Record of Decision
GE Farrell Road Site
Geddes (T), Onondaga County
Site Number 7-34-055

DECLARATION STATEMENT - RECORD OF DECISION

GE Farrell Road Inactive Hazardous Waste Site Geddes, Onondaga County, New York Site No. 7-34-055

FORMER GE
FARRELL ROAD SITE
POTENTIAL GROUNDWATER EXTRACTION
SYSTEM ESTIMATED ZONE
OF INFLUENCE

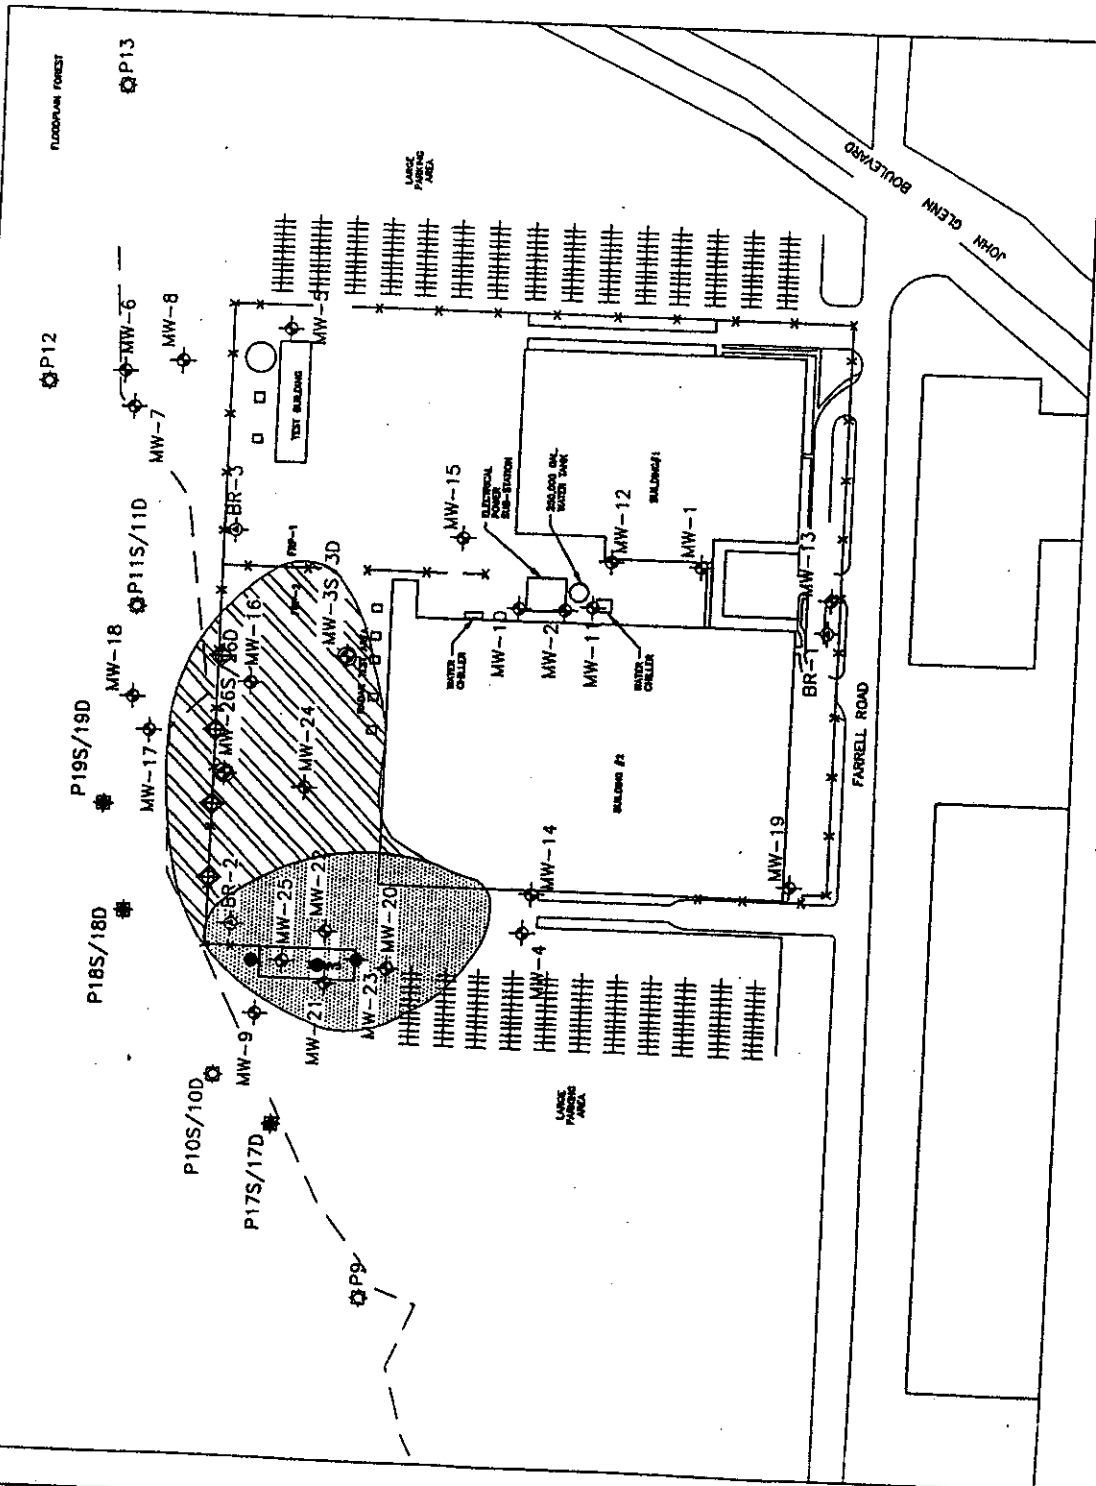
In addition, the reference to Figure 4 on page 23 and its inclusion on page 25 of the PRAP is inappropriate. This figure was developed for alternative analysis, and LMC must have an opportunity in the design phase to make final determinations about elements of the final remedy such as well number and placement. It would be appropriate to reference this figure only in a section of the ROD where remedial alternatives are evaluated.

Figure 4 is included to show the estimated radius of influence of the groundwater treatment system, and to allow people to more clearly visualize the site remedy. The figure clearly refers to a potential groundwater extraction system, and inclusion of the figure does not in any way restrict the design of the treatment system in terms of design elements such as well number and placement. No change was made.
